STERLING RANCH FILING 4

GRADING AND EROSION CONTROL PLANS

NOVEMBER 2022
PCD FILING NO. : SP-22-030

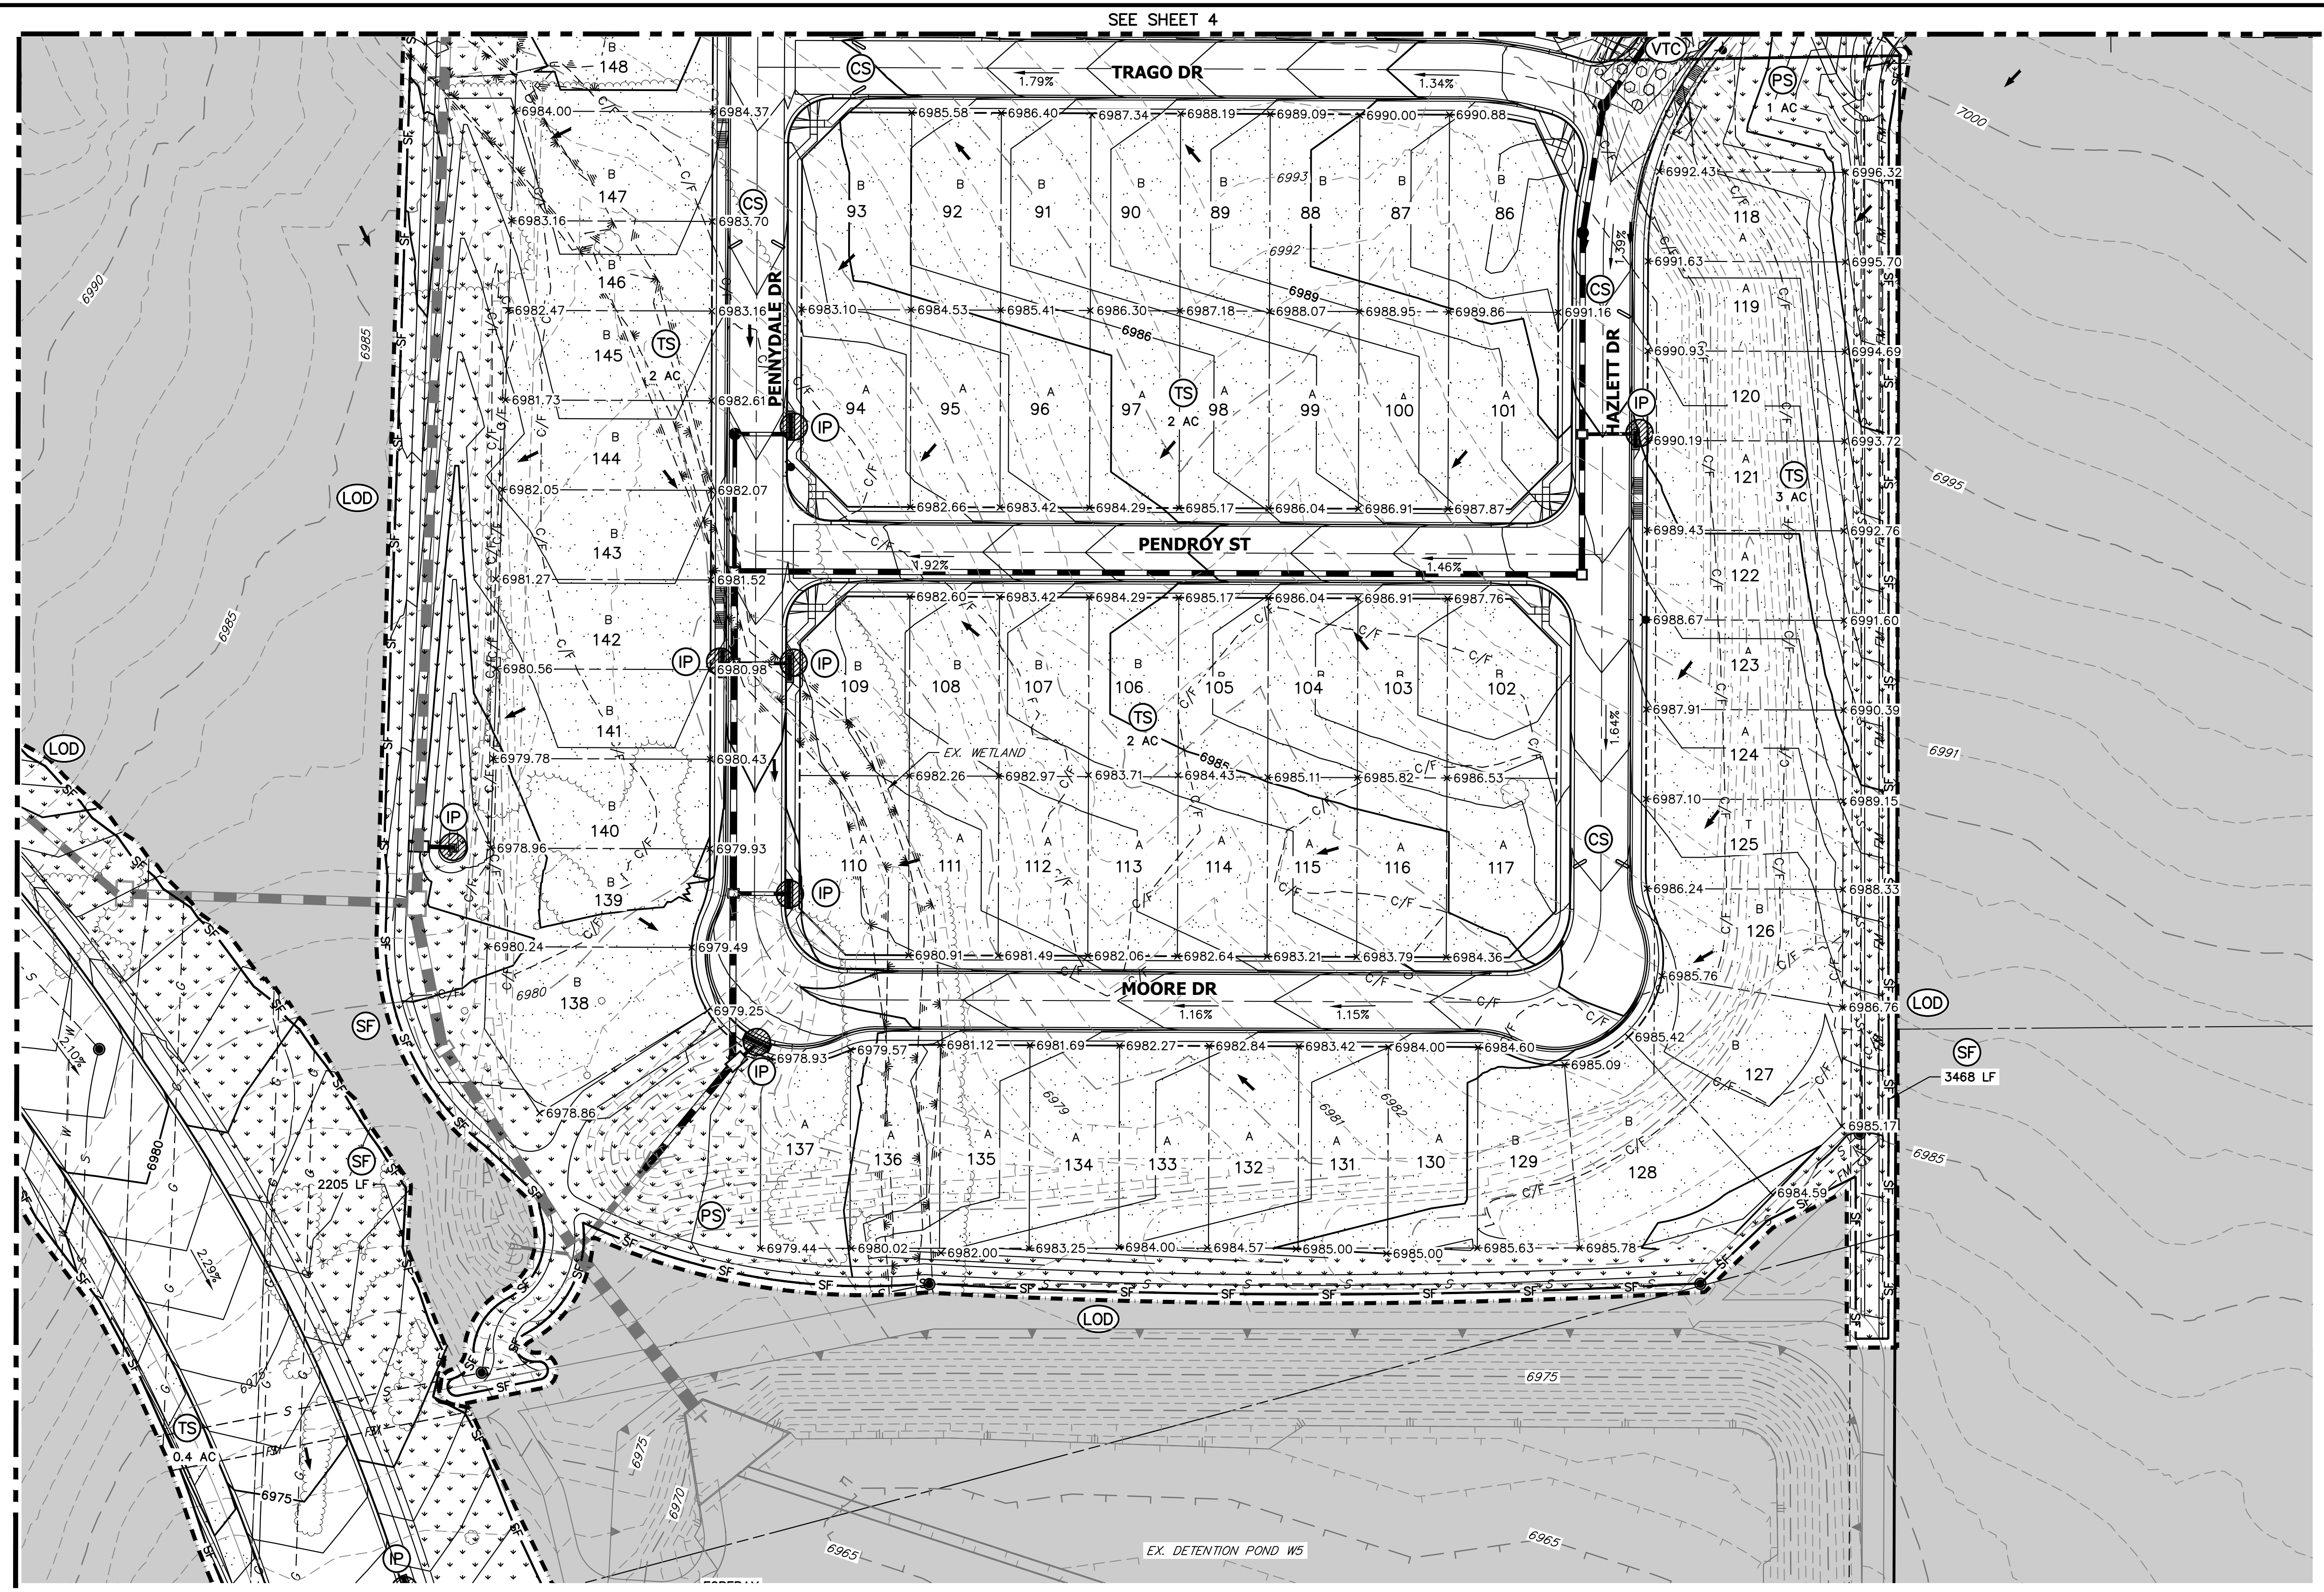
label trail/maint. access roads

STERLING RANCH FILING 4
GRADING & EROSION CONTROL PLAN

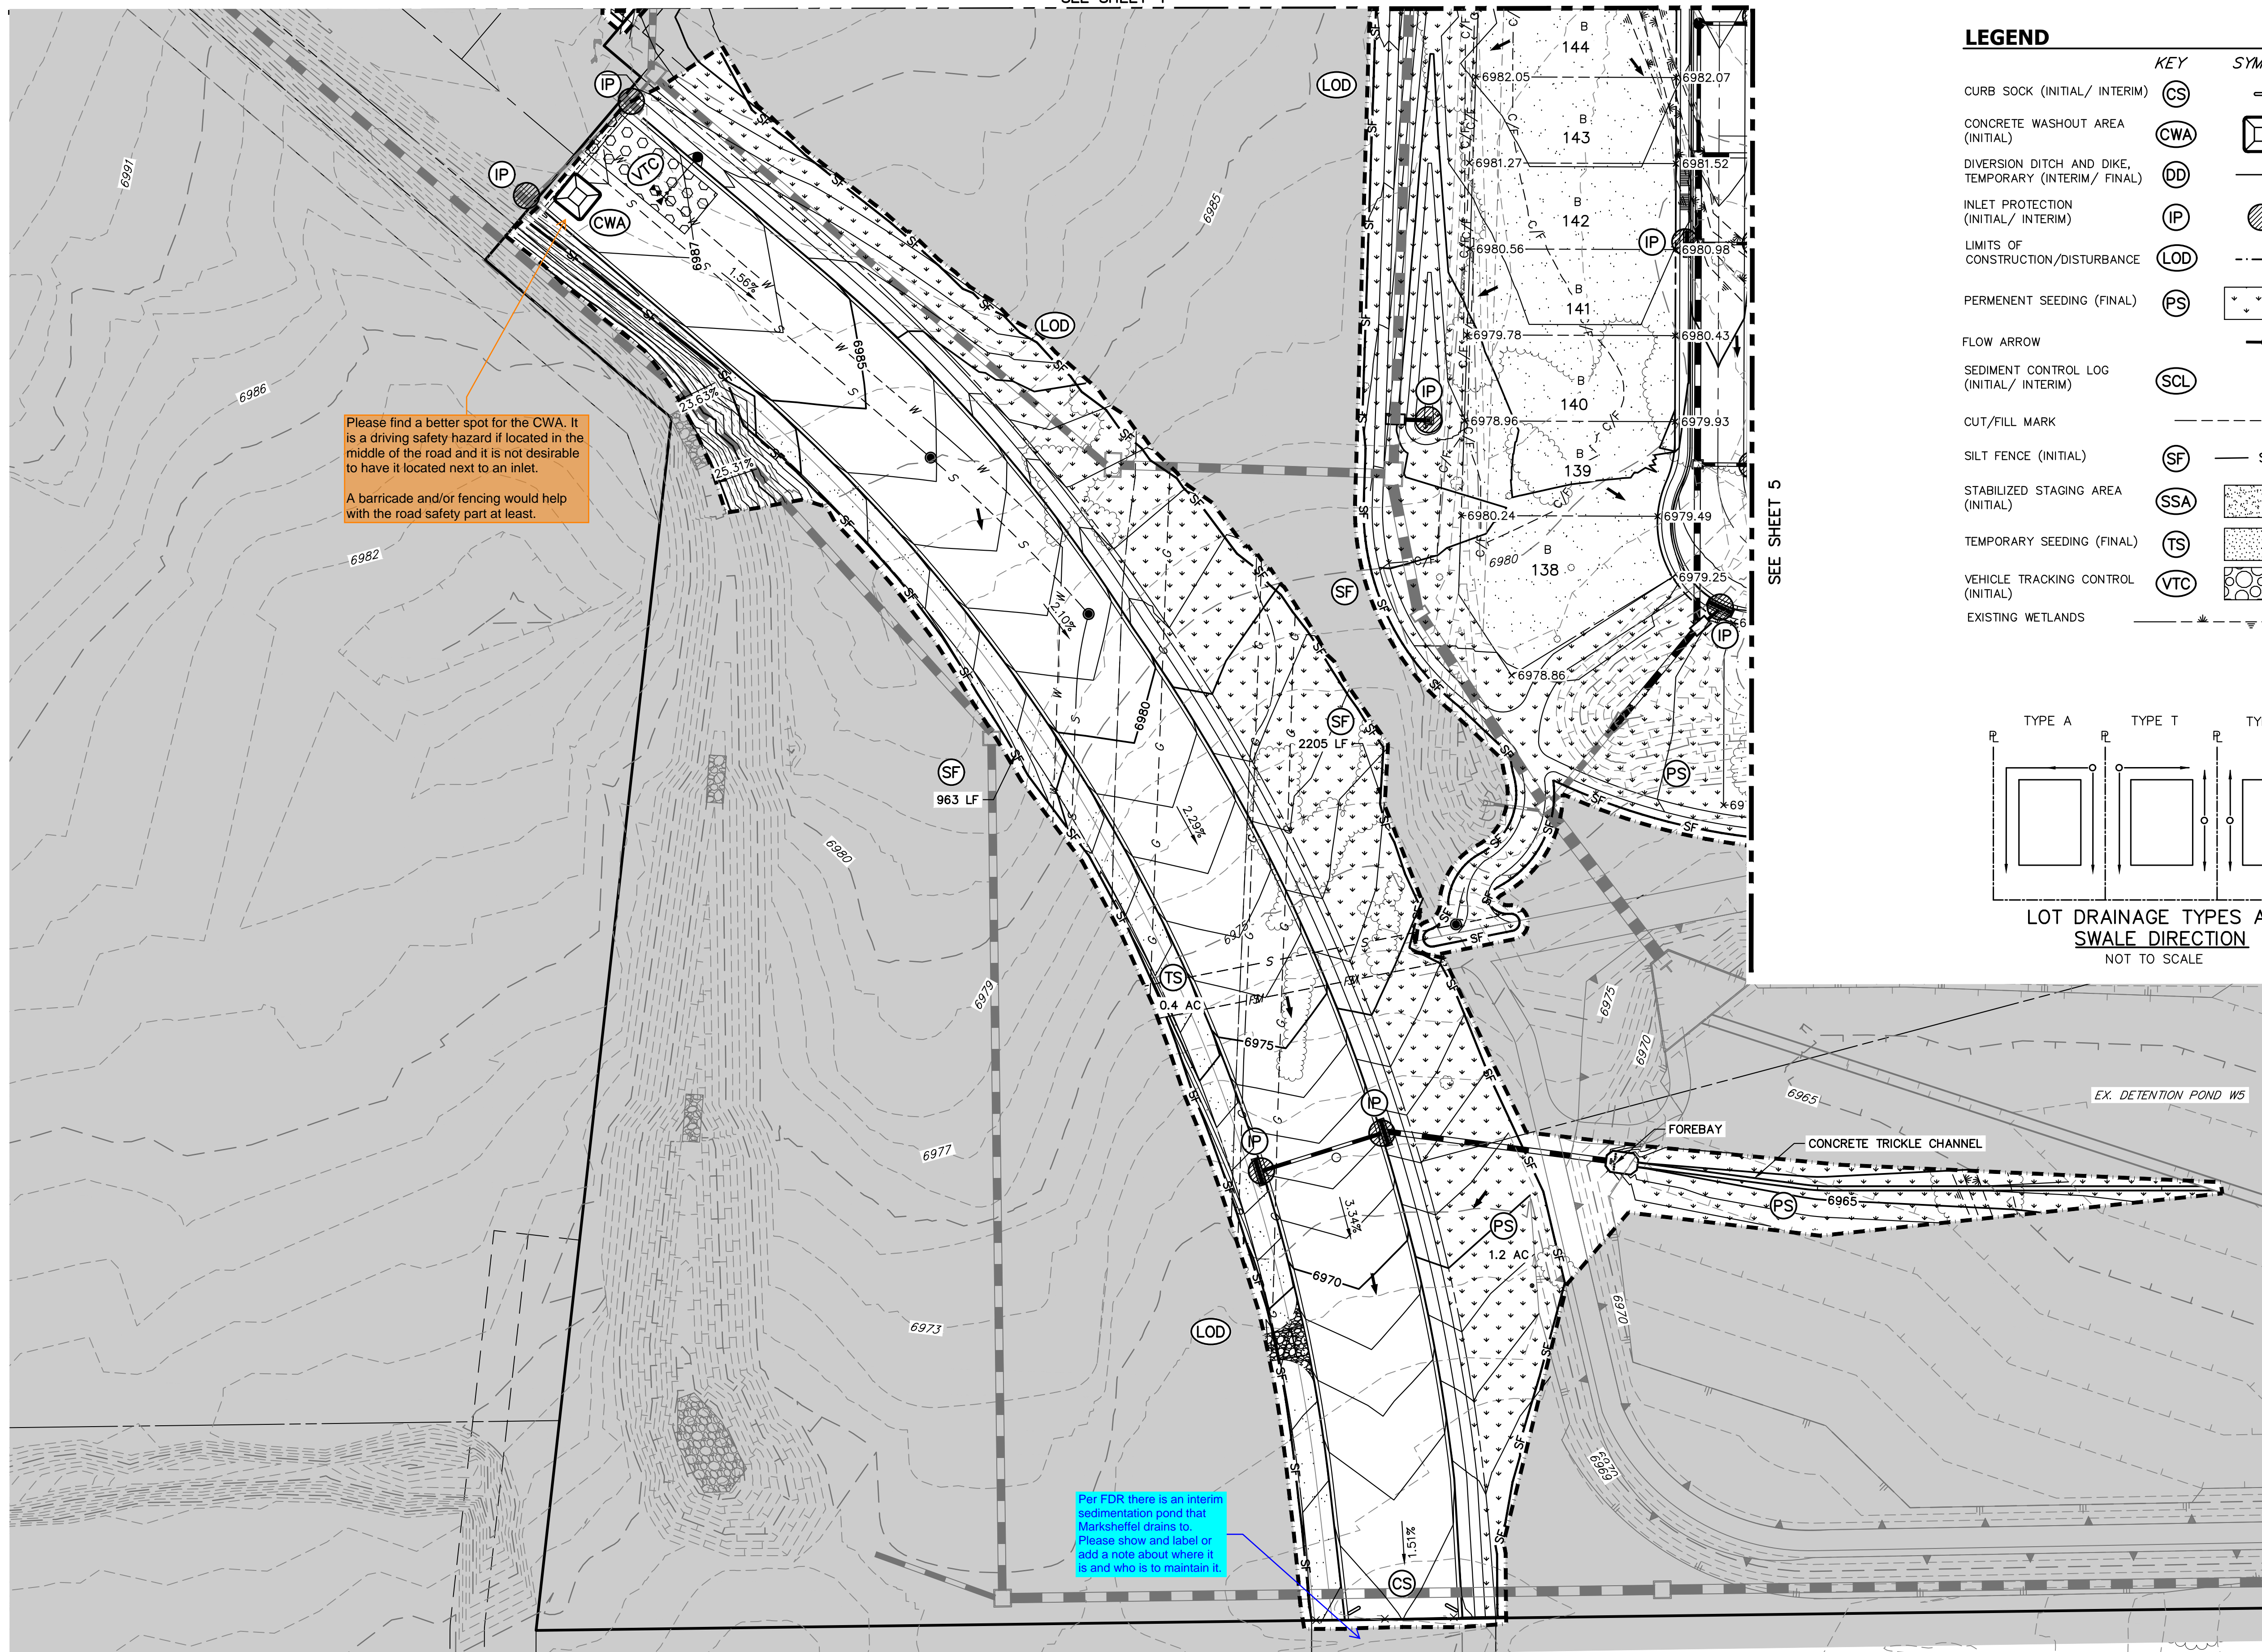
Please find a better spot for the CWA. It is a driving safety hazard if located in the middle of the road and it is not desirable to have it located next to an inlet.
A barricade and/or fencing would help with the road safety part at least.

Per FDR there is an interim sedimentation pond that Marksheffel drains to. Please show and label or add a note about where it is and who is to maintain it.
